Product Change Notification - SYST-01VKOT288

ERRATA - PIC32MZ Embedded Connectivity with Floating Point Unit (EF) Family Silicon Errat

PIC32MZ Embedded Connectivity with Floating Point Unit (EF) Family Silicon Errata and Data Sheet Clarification

FIGURE 1: Posc CRYSTAL CIRCUIT

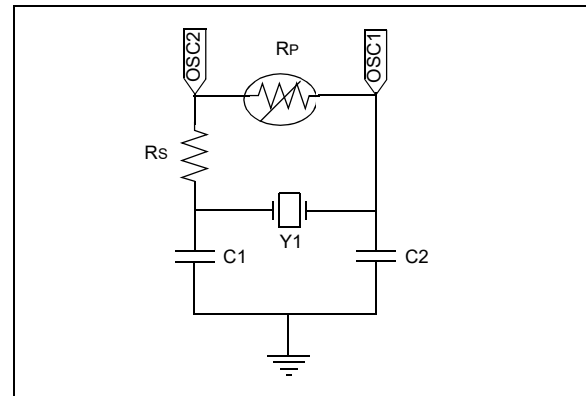
Revision A1 Silicon: A crystal oscillator cannot be used as an input to the Primary Oscillator (Posc) pins OSC1 and OSC2.

Revision A3 and B2 Silicon: The POSC has been tested in a normal power-up sequence and supports specific crystal operation.

The Primary Oscillator (Posc) has been characterized to operate at 8 MHz, 12 MHz, and 24 MHz when the circuit in [Figure 1](#) is implemented, and the operating conditions listed in [Table 3](#) are met.

- Note 1:** Using any other crystal frequency will require special component selection and characterization.
- Note 2:** A parallel resistor (Rp) should not be used to increase the gain of the POSC.

Alternatively, use an external clock or the Internal FRC oscillator.
